**Date:** March 9, 2022

**Subject:** Falcon Commerce Center Filing No. 2 - Civil Construction Plans

FALCON COMMERCE CENTER FILING NO. 2  
CIVIL CONSTRUCTION PLANS  
TERRAZZO DRIVE EXTENSION AND UTILITY IMPROVEMENTS  
MONUMENT, COLORADO

SHEET  
**C511**  
 OF 26 SHEETS

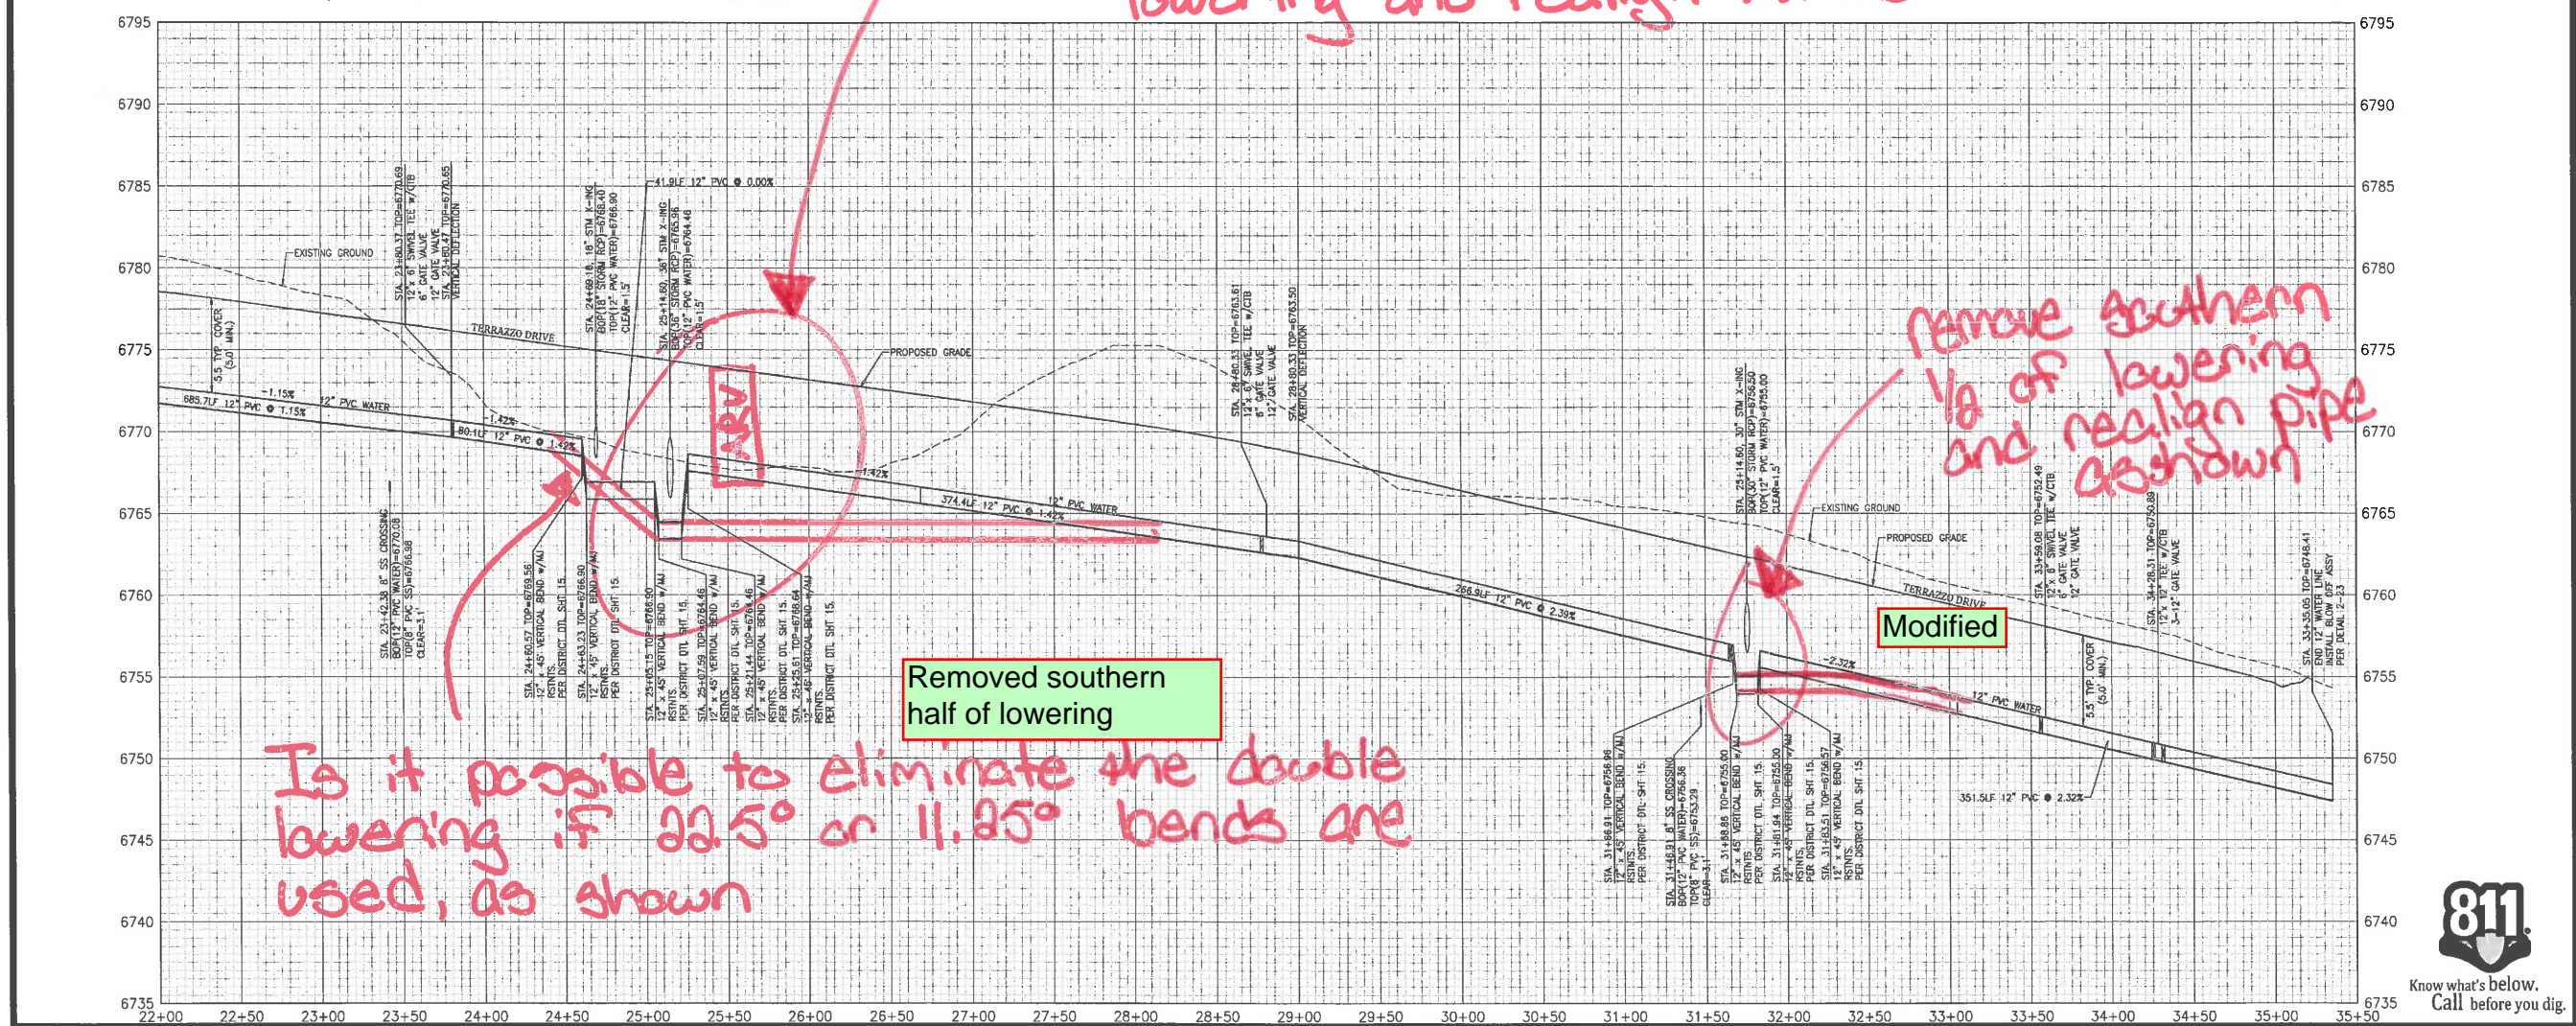
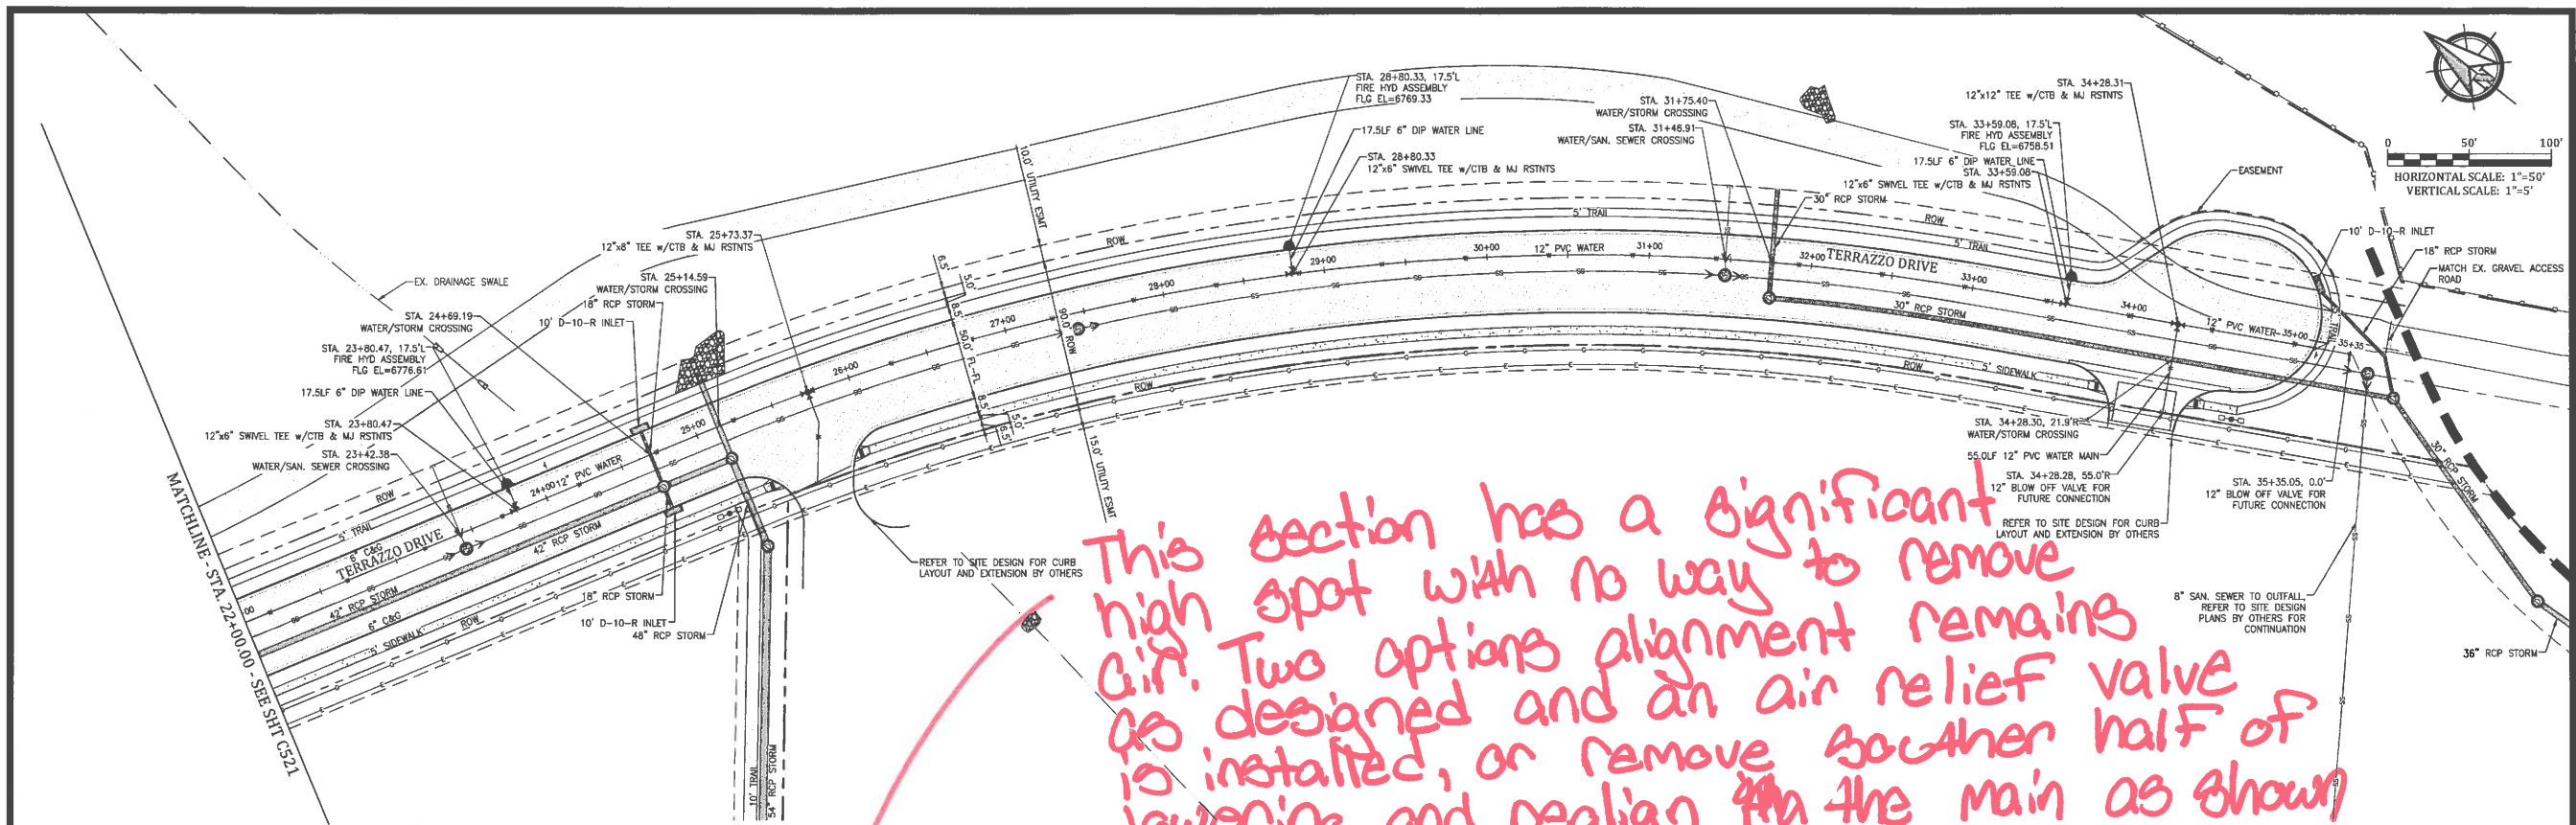
/ On Sheet C511, remove the southern half of the water lowering at Station 16+92. Realign the vertical profile to provide a maximum of 0% slope going south to north up to the crossing. See attached redline drawing.

**C513**

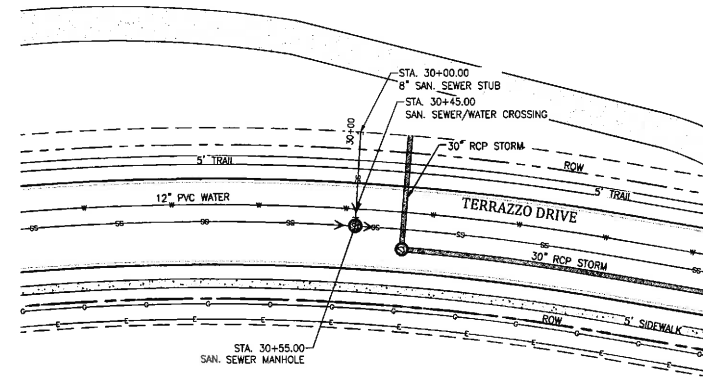
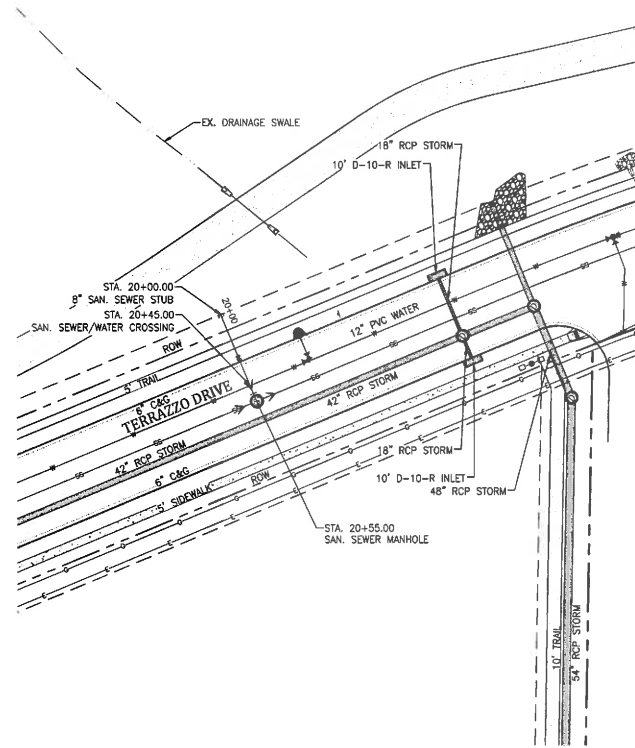
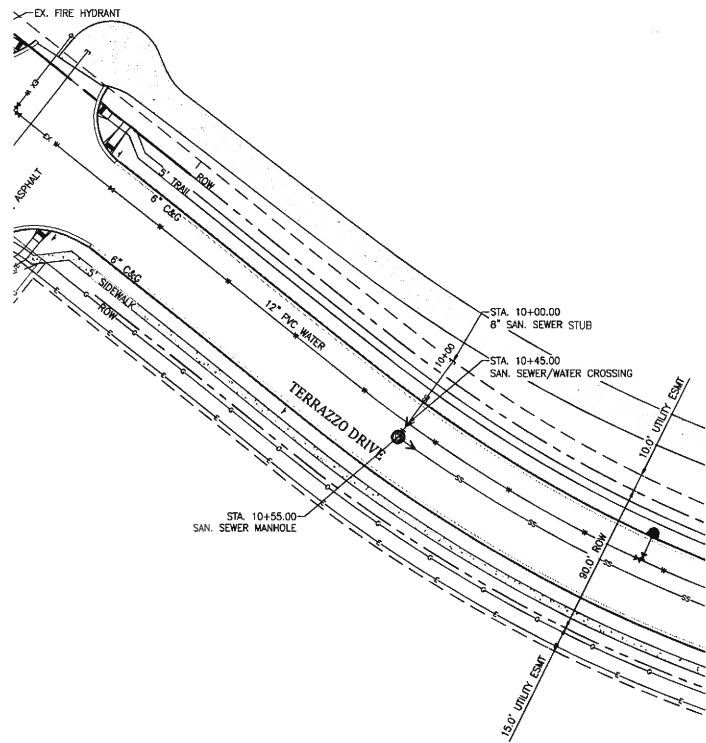
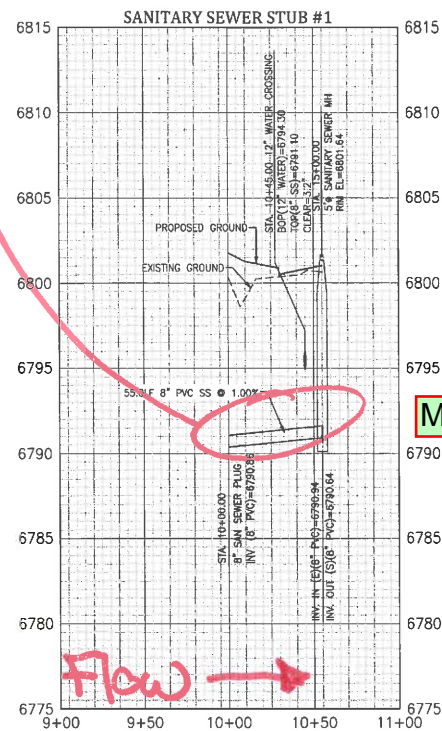
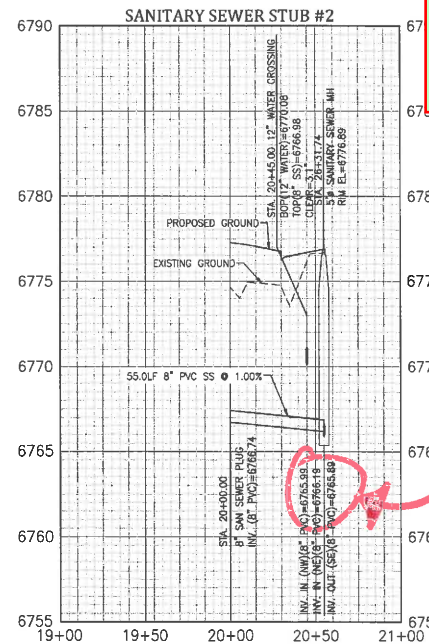
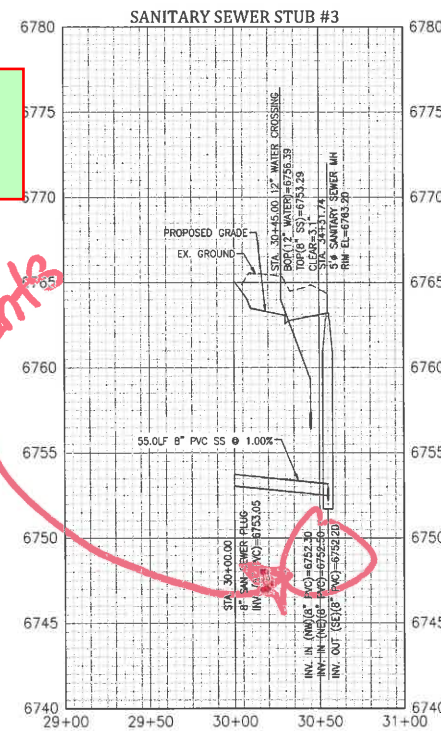
Sewer is sloped  
the wrong direction

See Previous  
invent Comments

Modified

Modified all san MHs to  
have 0.2' drops. Crows  
for laterals/main match
